Vogle Project

NRC DOCKET NUMBERS 50-424 AND 50-425
CONSTRUCTION PERMIT NUMBERS CPPR-108 AND CPPR-109
VOGTLE ELECTRIC GENERATING PLANT - UNITS 1 AND 2
REQUEST FOR SUPPLEMENTAL INFORMATION
DSER OPEN ITEMS 4 AND 5

Open Item 4: Verification of FSAR commitments on compaction of category 1 backfill

Open Item 5

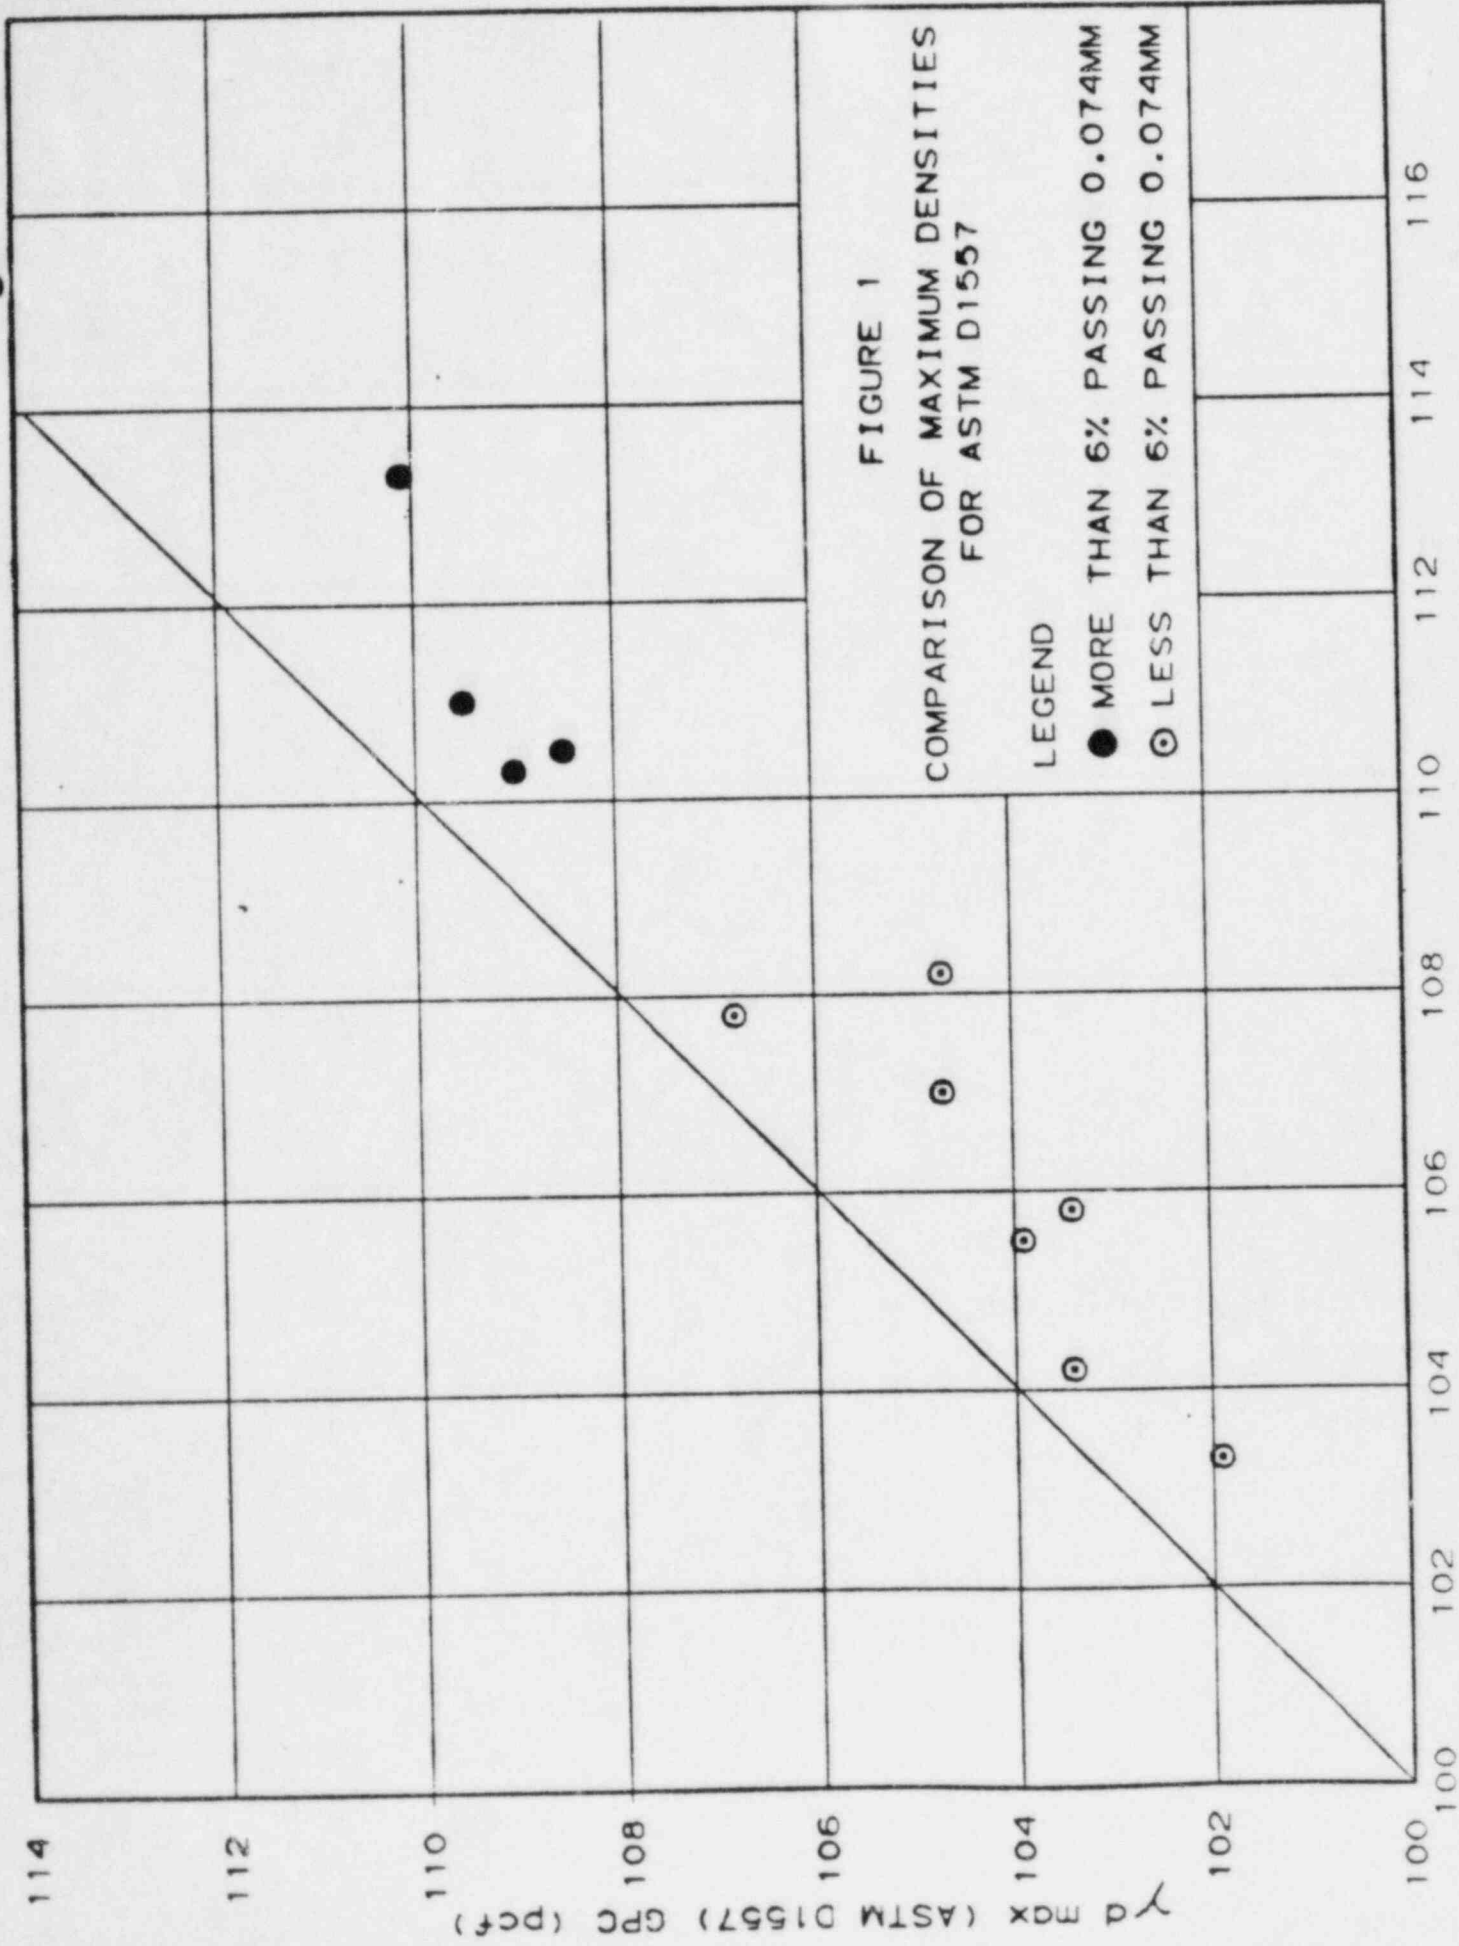
"(1) A comparison of the maximum dry densities determined by the field laboratory and the independent testing laboratory indicates that the independent laboratory results show higher values of maximum densities in all of the 12 tests performed using ASTM D 1557. The increase in densities ranged from 0.8 lb/ft^3 up to 3.5 lb/ft^3 . The maximum difference in dry density from the loosest state to the densest state for the medium to fine sand (SP) is about 20 lb/ft^3 . The differences in results between the testing laboratories for optimum moisture content determinations were more widely scattered--differences ranged from 7.6 percent moisture below optimum to 2.5 percent above for the tests on the same type of material."

The results of the confirmatory testing program are summarized in Table I. The comparison between the two laboratories for the ASTM D 1557 test is shown on Figure 1, and the data are recorded in Table II. This shows that the LETCO values are always somewhat larger than the GPC values by amounts varying from 0.8 to 3.5 pcf, with an average difference of about 1.8 pcf. What should be noted is the consistency between the two laboratories. The scatter of data about the average is about 0.7 pcf and is similar whether the amount of material passing the 0.074 mm size is more or less than 6 percent.

1. The two laboratories obtained values of ASTM D 1557 maximum density that were within the accuracy accepted by ASTM for different laboratories. The GPC values were lower by about 1.8 pcf on the average. However, as Figure 1 shows, the results all fall within a narrow band. The consistent difference between the two laboratories is attributed to the fact that LETCO performed the tests manually and GPC used a mechanical compactor, which is calibrated every 90 days. Since the mechanical compactor is an approved ASTM procedure, it is concluded that the GPC laboratory is carrying out the required tests correctly within the accuracy accepted by the ASTM and by a procedure accepted by the industry. Therefore, the PSAR and FSAR commitments with regards to density have been met.

FIGURE 2
 VARIATION OF γ_d MAX
 WITH PERCENT FINER
 THAN 0.074MM

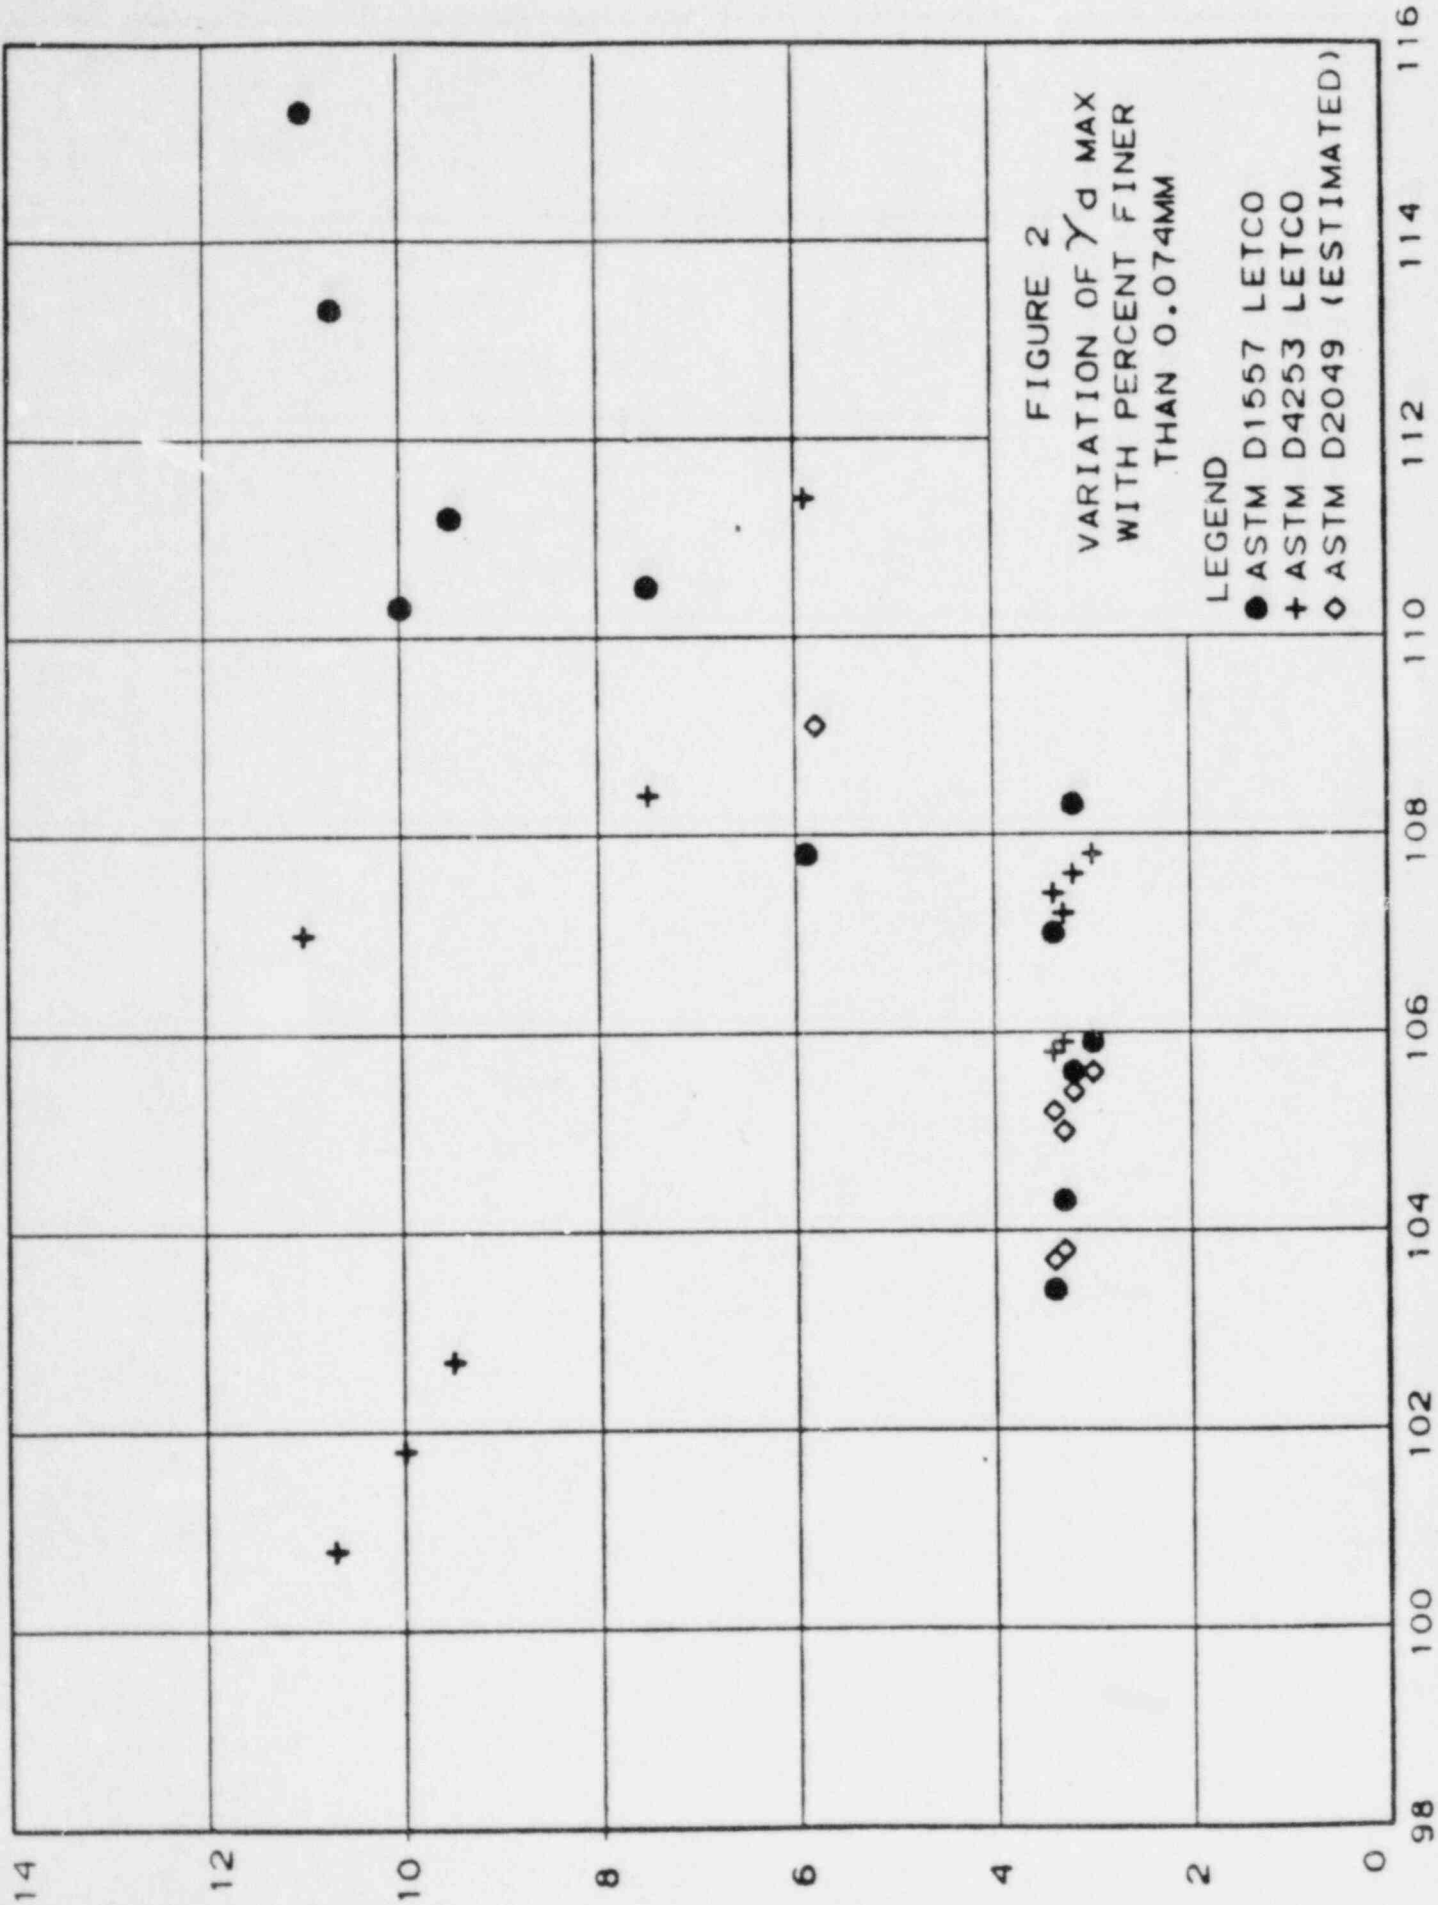
"(2) The test results also indicate that the backfill soils which have a small amount of fines (less than 6 percent passing the No. 200 sieve) attained their highest densities when tested in the relative density test (ASTM D 4253) in six of the seven tests performed. The increase in maximum dry densities between modified Proctor (ASTM D 1557) by the field laboratory and the relative density (ASTM D 4253) testing ranged from 2.4 lb/ft³ up to 4.5 lb/ft³. Recognition of these results would encourage a modification to current control procedures that requires the running of both the relative density test and the modified Proctor test in order to establish the maximum dry densities and percent compaction for this type backfill which has the small amount of fines."

Figure 2 shows LETCO's results for ASTM D 1557 and D 4253 maximum densities plotted against percent finer than the 0.074 mm size. The peak vibration amplitude of 0.0175 inch was used to determine maximum density for samples with 6 percent or less passing the 0.074 mm size. Based on the above discussion, in order to correlate with the ASTM D 2049 maximum densities, the maximum values obtained by ASTM D 4253 were reduced by 2.2 pcf.

Figure 2 also shows the relationship for ASTM D 4253 samples with less than 6 percent passing the 0.074 mm size corrected by 2.2 pcf to estimate ASTM D 2049 maximum density. The points so plotted lie within the LETCO ASTM D 1557 test data scatter. The data for the material with less than 6 percent finer than 0.074 mm are given in Table III.

Furthermore, as can be seen in Figure 2, the confirmatory testing program showed that, although there was slightly more scatter in ASTM D 1557 when the percent finer than 0.074 mm size was less than 6 percent than with ASTM D 2049, ASTM D 1557 provides an acceptable basis for control of the entire fill and should continue to be the control test at Vogtle.
